This informal document is submitted by the Informal Working Group (IWG) Particle Measurement Programme to inform and update the GRPE of the work of the IWG on the amendment of UN GTR 15 Annexes 5, 6 and 7 to:

This is an explanatory note accompanying the consolidated document addressing the changes to the current methodology and the proposed changes for the second alternative option to extend the particle size detection range to 10 nm particles (GRPE-81-10).

Table 1: Main changes to SPN23 and changes/additions for SPN10

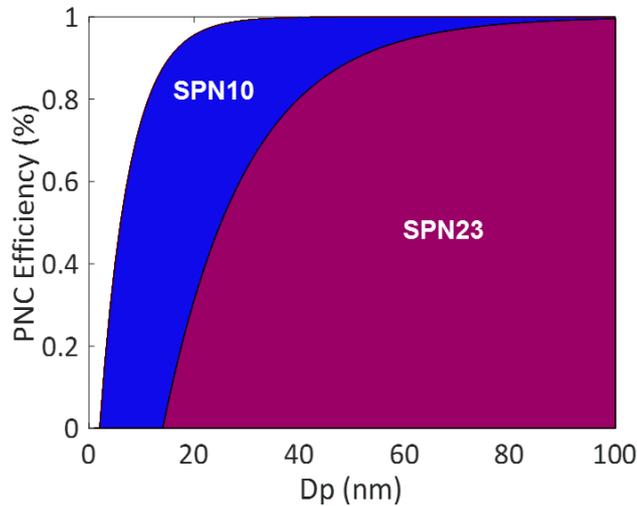
A specific technical issue stemmed from the concern that to certify a vehicle for two different regions applying different PN limits (i.e. PN10 and PN23) either two different instruments or double testing might be required. This would lead in any case to increased testing costs and burden. Both those situations might be avoided if a test performed using the SPN 10 measurement procedure could also cover the SPN23 nm test.

In principle measuring SPN10 should result in higher PN values and therefore if the PN23 limit is met it can be concluded that the same limit would be more easily met when using the SPN23 procedure (see picture below). The PMP IWG believes that this option is acceptable if any party would like to implement it.
